Our ref: AU015874

Date: 12 September 2025

Captain Cook Highway, Killaloe - Material Change of Use for an Extractive Industry for the extraction of approximately 30,000 tonnes of sand per year.
Response to further issues letter and submission received during Public Notification
Your Ref: MCUI 2024_5628/1

Figure 1: Indicative Cross Section

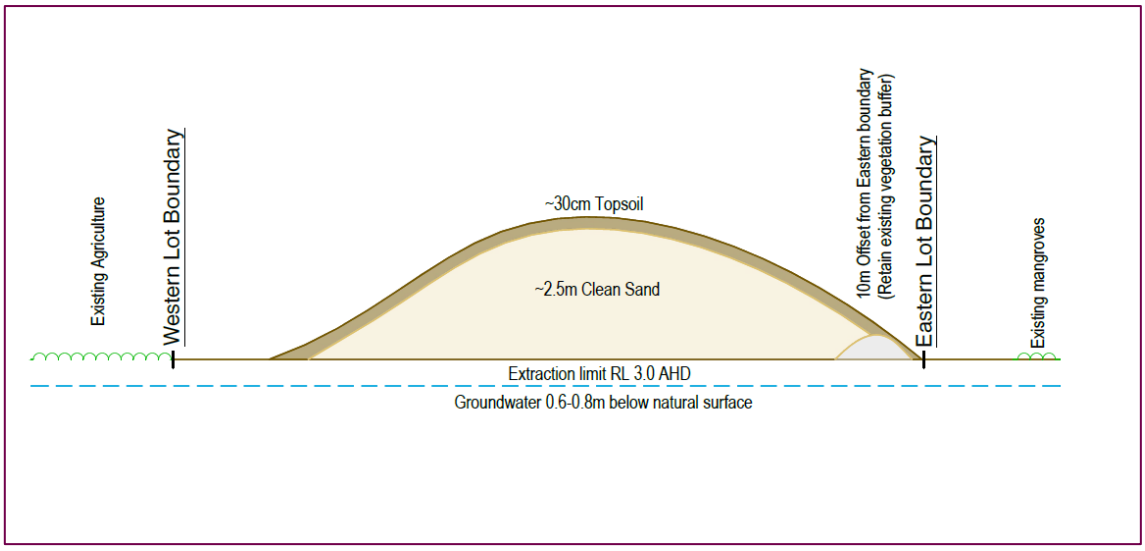
> The surrounding land is affected by storm tide inundation, coastal erosion and flooding. The creation of a large depression on the land will change the dynamics of the impacts of storm tide inundation, coastal erosion and flooding. Specific details on the pre, post and extraction phases for these matters is required. Plans should clearly demonstrate the operation and nominate all relative levels to finished surface. Given these concerns a bulk earthworks plan illustrating the intended extent of extraction that is to also align with the location and depth of the resource should be provided.

The development proposes the reduction of an existing sand dune/ridge to its natural ground level. It is not proposed to extract sand below RL3.0AHD, which is the ground level at the foot of the dune, and create a 'large depression". This was addressed in the supporting planning report submitted with the application. Further details of the level of extraction are contained within the response to the information requested by the Department of Environment, Tourism, Science and Innovation (DETSI), attached at **Appendix A - Response to the Department of Environment, Tourism, Science and Innovation**.

In address the concerns of DETSI a 10m buffer is proposed to the eastern boundary to address concerns relating to storm tide inundation and to prevent impacts to the adjoining mangrove forest.

Below in **Figure 1** is a cross section providing an illustration of the proposed depth of extraction.
